AGENDA
PLANNING AND ZONING COMMISSION MEETING
CITY OF CREVE COEUR, MISSOURI
MONDAY, OCTOBER 20, 2014
7:00 PM

Application #14-032: Approval of a Site Concept Plan for Barnes Jewish West County Hospital Campus and Approval of a Conditional Use Permit and Site Development Plan for a 16-Bed Hospice House at 970 North Mason Road

**APPLICATION TO PLANNING AND ZONING COMMISSION
#14-032 BARNES JEWISH WEST COUNTY HOSPITAL SITE CONCEPT PLAN
AND APPROVAL OF A CONDITIONAL USE PERMIT AND SITE DEVELOPMENT
PLAN FOR A 16-BED HOSPICE HOUSE**

FENCE PLACEMENT AND DESIGN

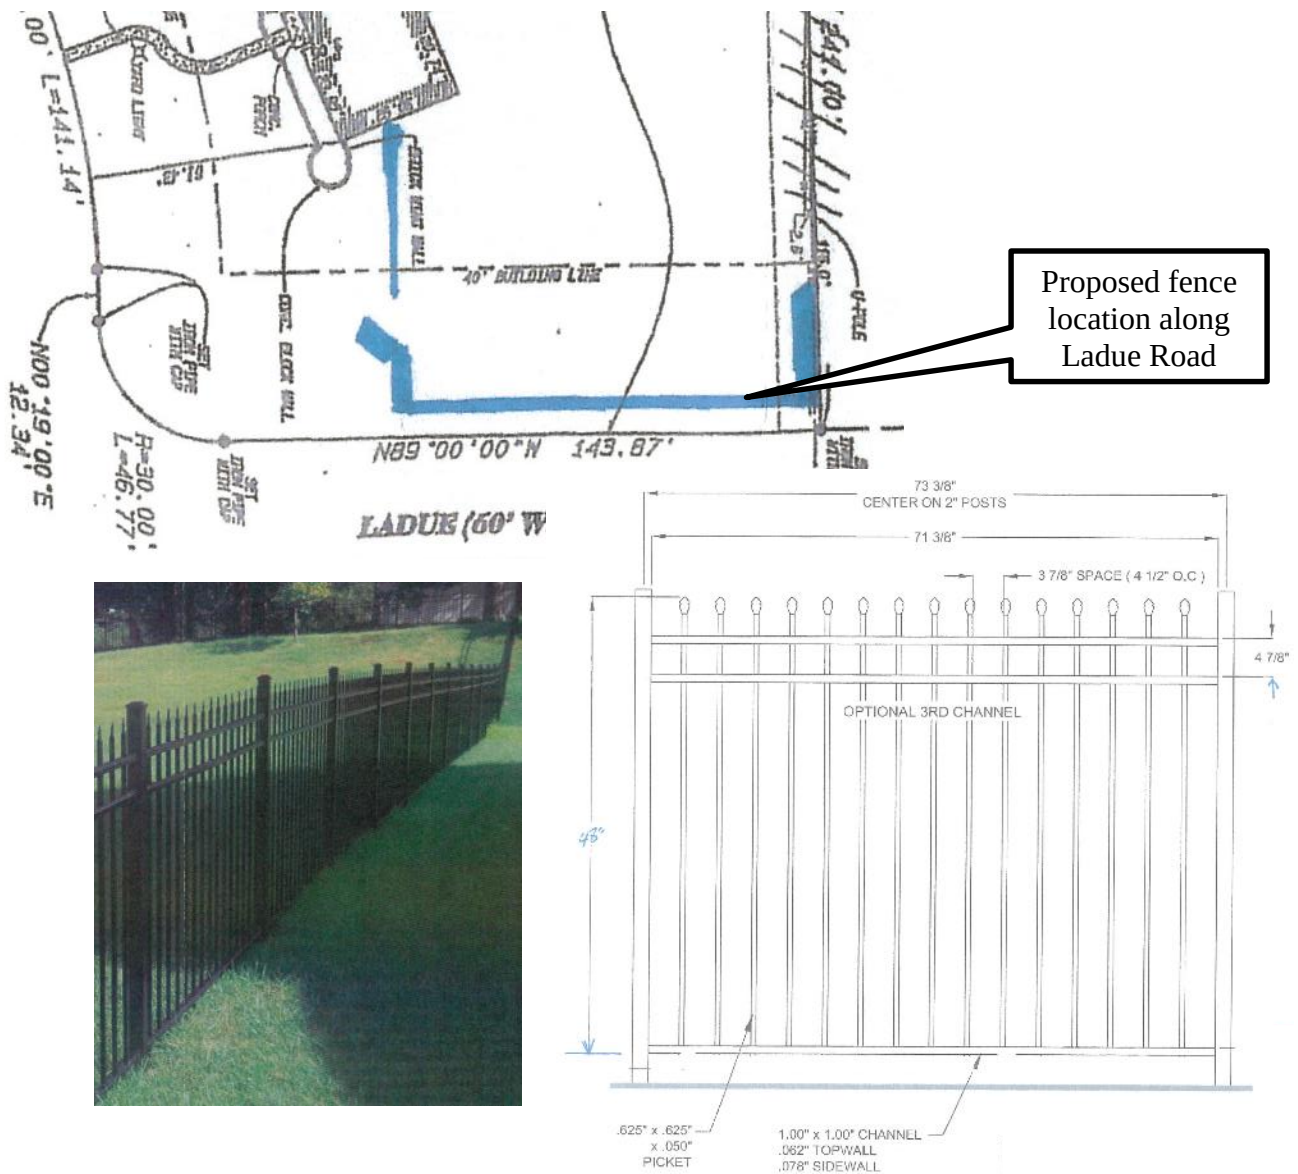
The proposed fence would be a four-foot tall, open-slatted, black metal fence from the south elevation of the building headed south toward Ladue Road to a point approximately 16 feet from the south property line, then turning east for approximately 102 feet to the east property line and then turn north to meet the existing neighbor's fence along the shared property line. The south property line is approximately 11 feet from the sidewalk pavement of Ladue Road. Below is a close up of the site plan showing the fence configuration along Ladue Road, and an example photo of the style of fence along with the cut-sheet of the fence. The aerial photo and site photos suggests that little or none of the existing scrub along the street (mostly shrub honeysuckle) will need to be removed for the fence.

Further, the Design Guidelines recommends the use of natural “green” materials, and discourages the use of synthetic, and highly reflective materials. The existing trees and shrubs along Ladue Road provide a vegetative screen of the yard, and would limit any impact of the fence viewable from the right-of-way in keeping with the character of homes in the area. Further, the open metal-picket fence design and height of four-feet would not create a significant interruption in the public line of sight, even if the honeysuckle vegetation were removed. The fence provides a degree of safety for children and pets by keeping them away from Ladue Road where posted speed limits are 40 miles per hour, versus 25 miles per hour along a typical subdivision street. Similar arguments were made for the fences approved nearby and are typically cited in such applications. In other words, the fence appears to generally satisfy the Comprehensive Plan and Design Guidelines.

Further, as discussed with prior applications, honeysuckle is an invasive species and there has been discussion at the Horticulture, Environmental and Beautification Committee that it should be a requirement with any redevelopment project that it be removed. If the Planning and Zoning Commission wishes to see the invasive Honeysuckle removed and replaced with additional landscaping, they should add an appropriate condition of approval in concert with discussions with the applicant.

“I move to approve the site plan for the fence 16 feet from the south property line within the area equivalent to the front-yard setback along Ladue Road for the property addressed as 25 Ladue Meadows submitted with Application #14-031, as presented to the Planning and Zoning Commission on October 20, 2014” (conditions may be added by separate motion).

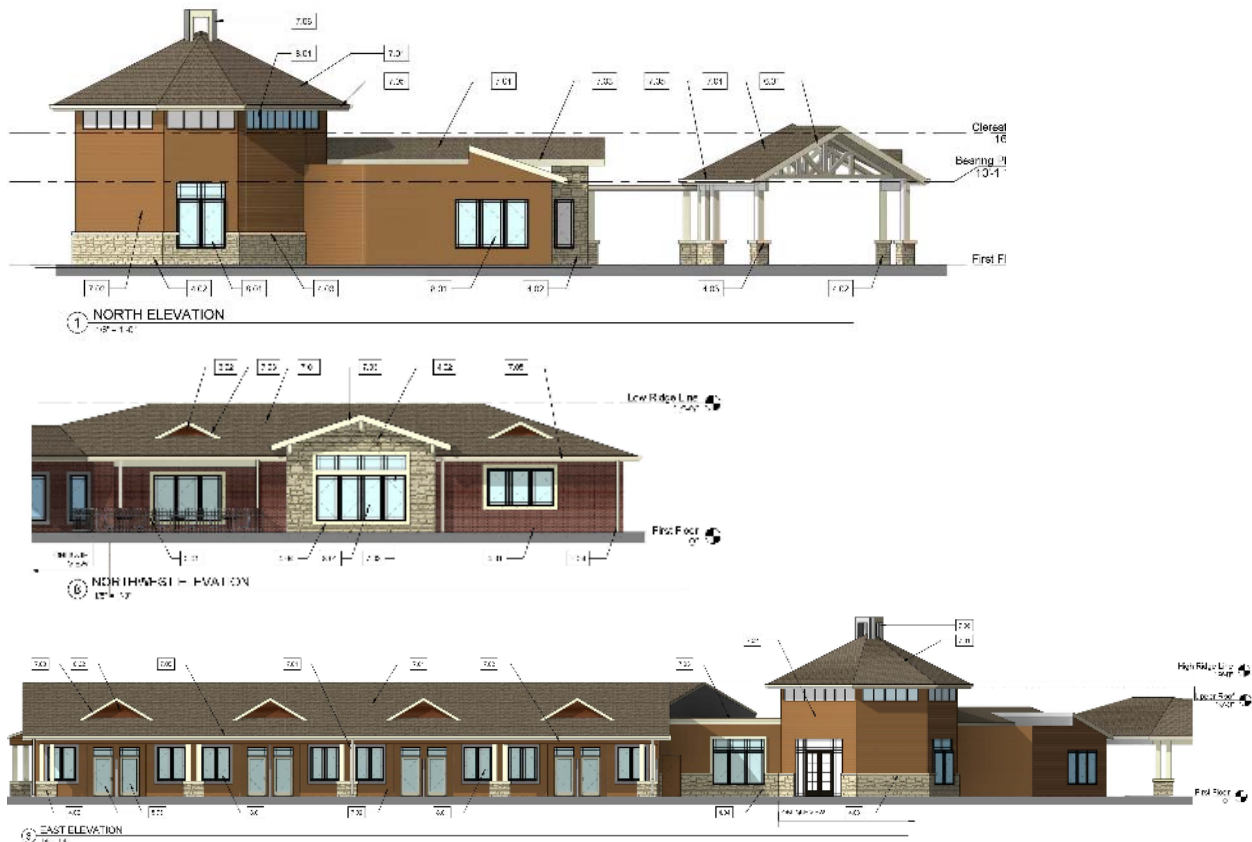
The Applicant is seeking approval of the site development plan and the conditional use permit for Phase I of the Hospice Care Center. The existing berm along Mason will provide significant screening, and the applicant will carry the berm and landscaping around the building, per the detail of the plan below:

The proposed facility is a 19,000 square foot, ranch style, 16 bed hospice house to provide the level of specialty care needed for patients with acute end-of-life needs. The building has a single story, and is residential in character. The materials consist of fiber cement siding with a cast stone trim, that are consistently carried around all sides of the building.

SHEET TITLE:
**SITE
PHOTOMETRICS**

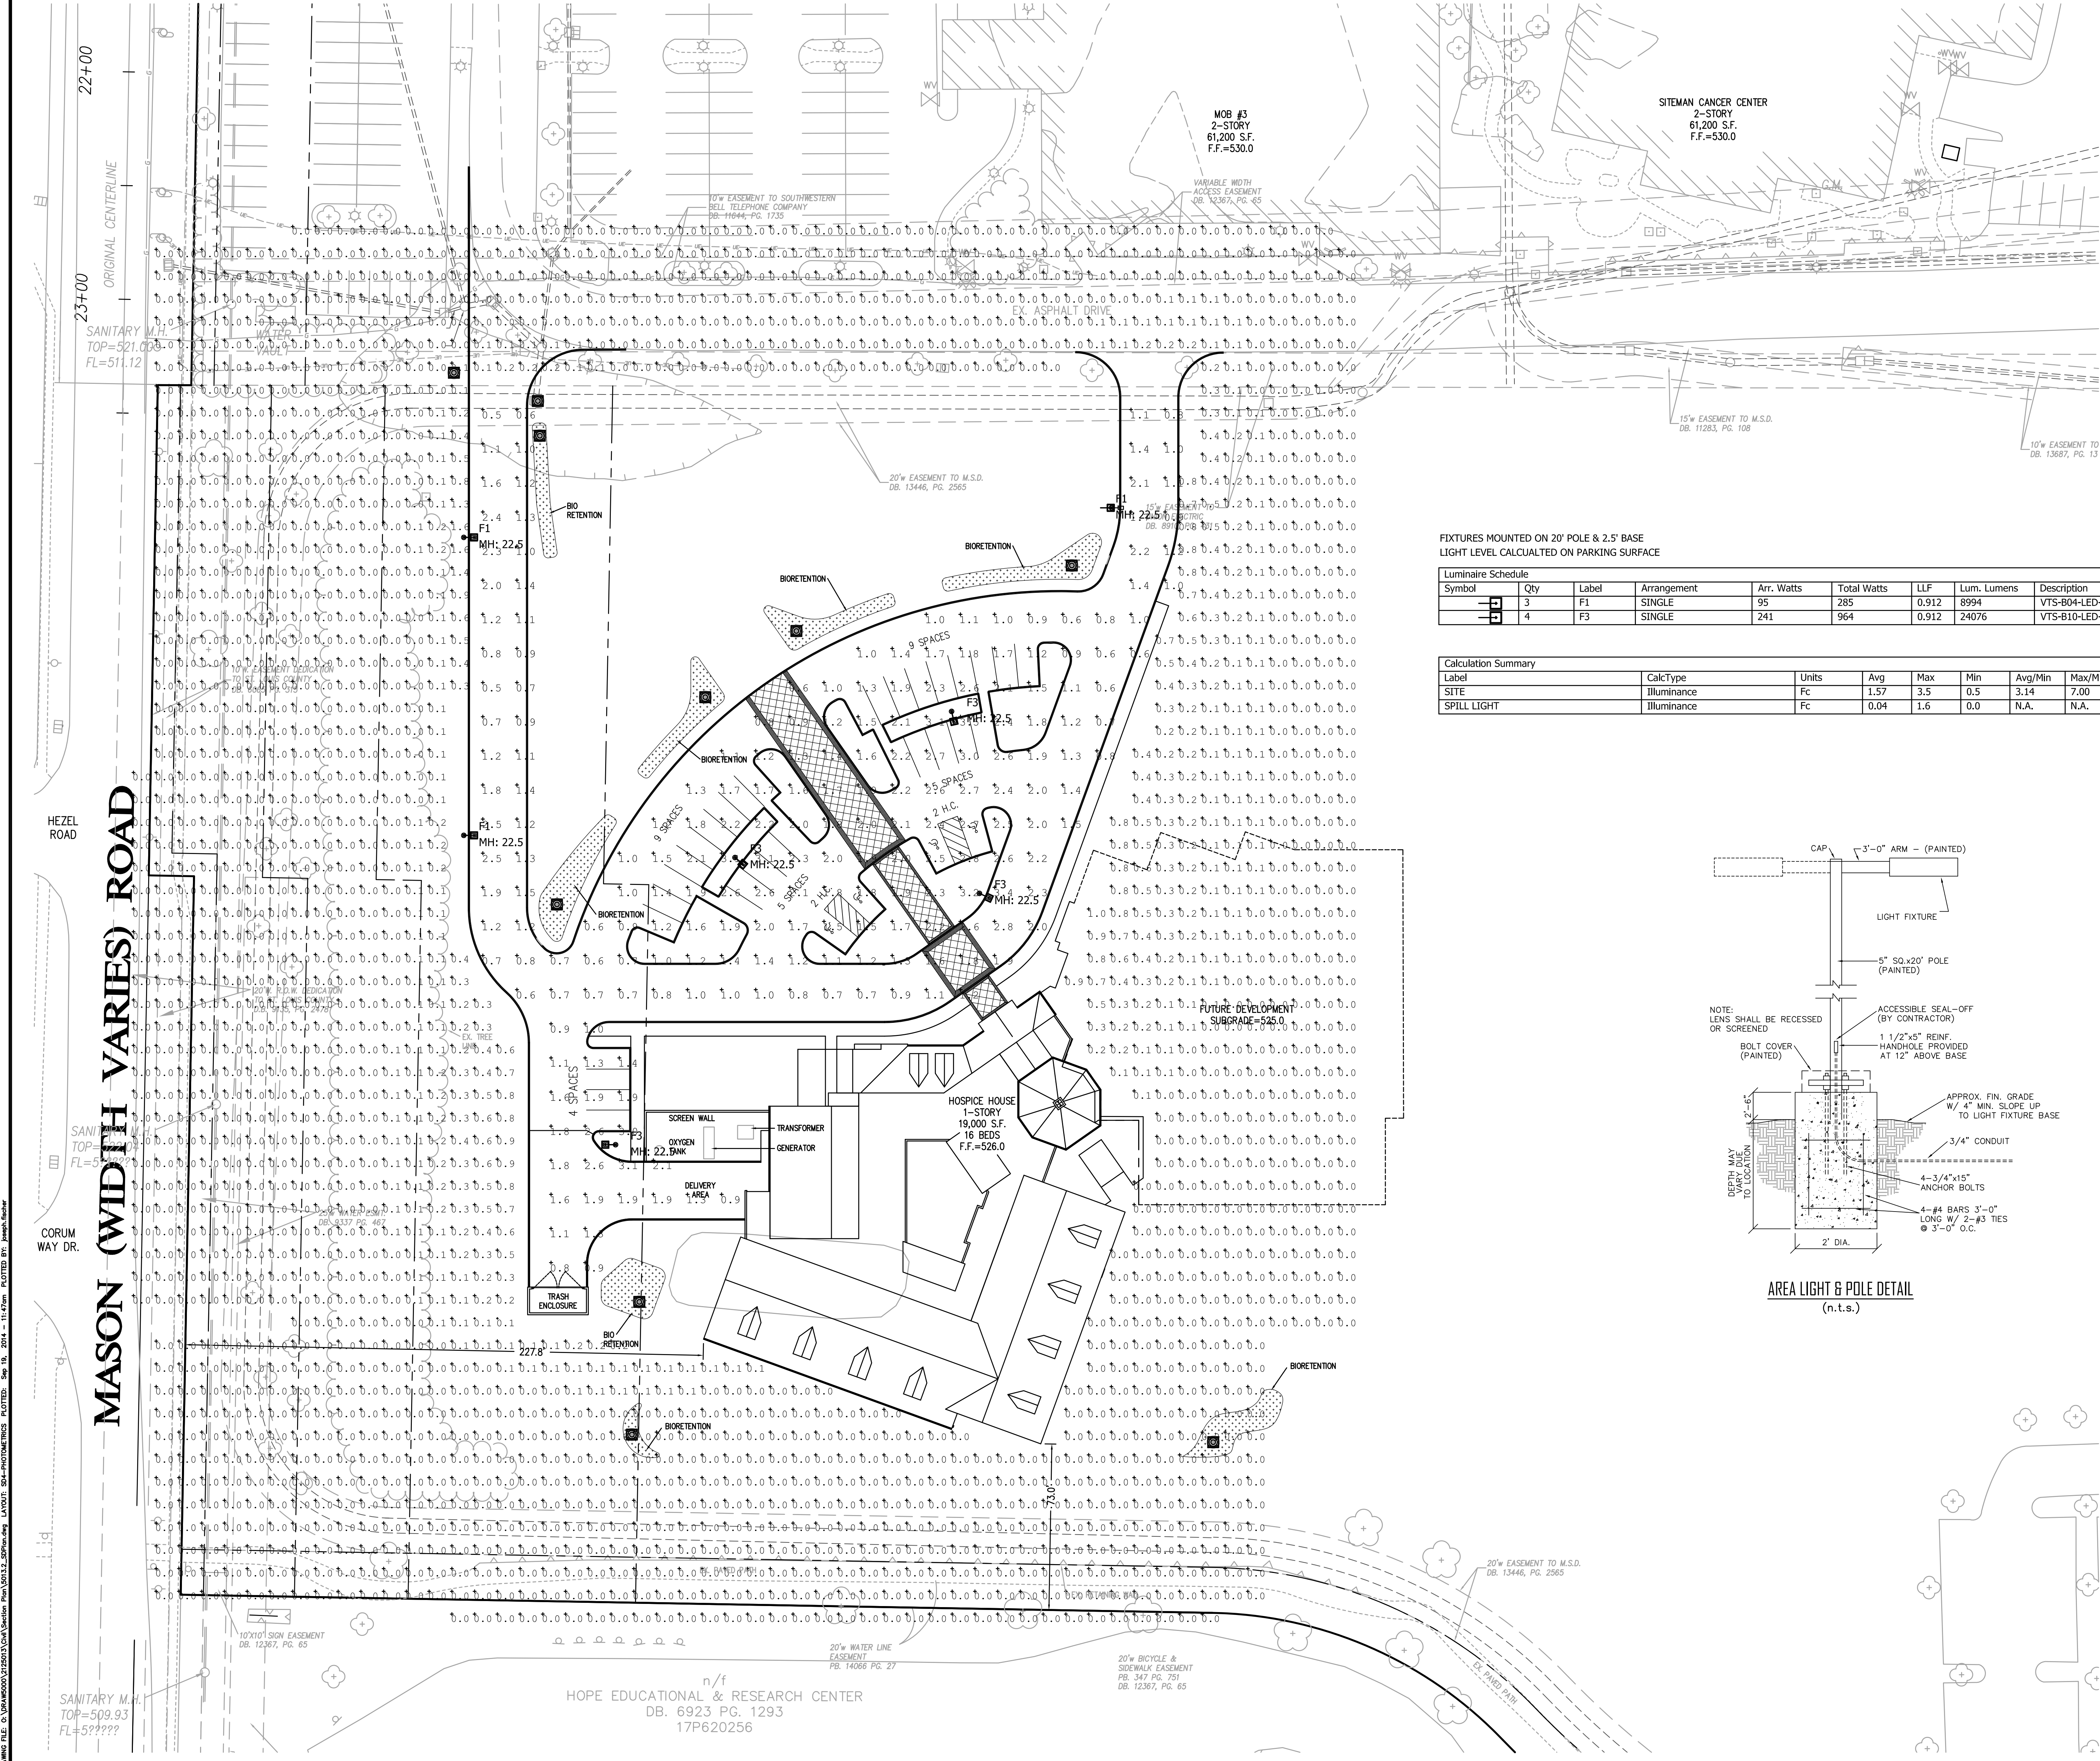
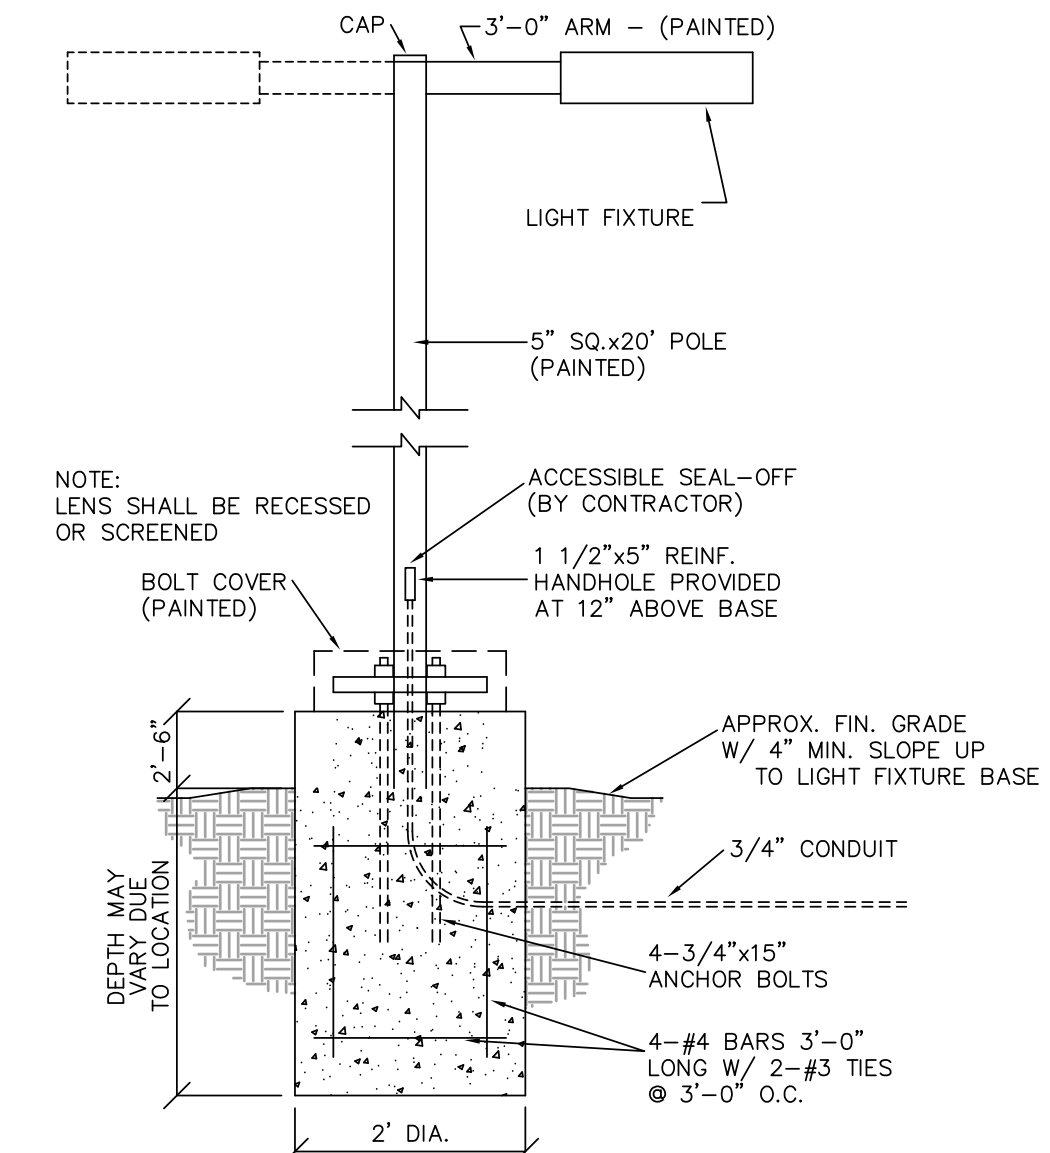
The Applicant's photometric plan indicates that no direct light will be leaving the property, and should meet with the illumination requirements below:
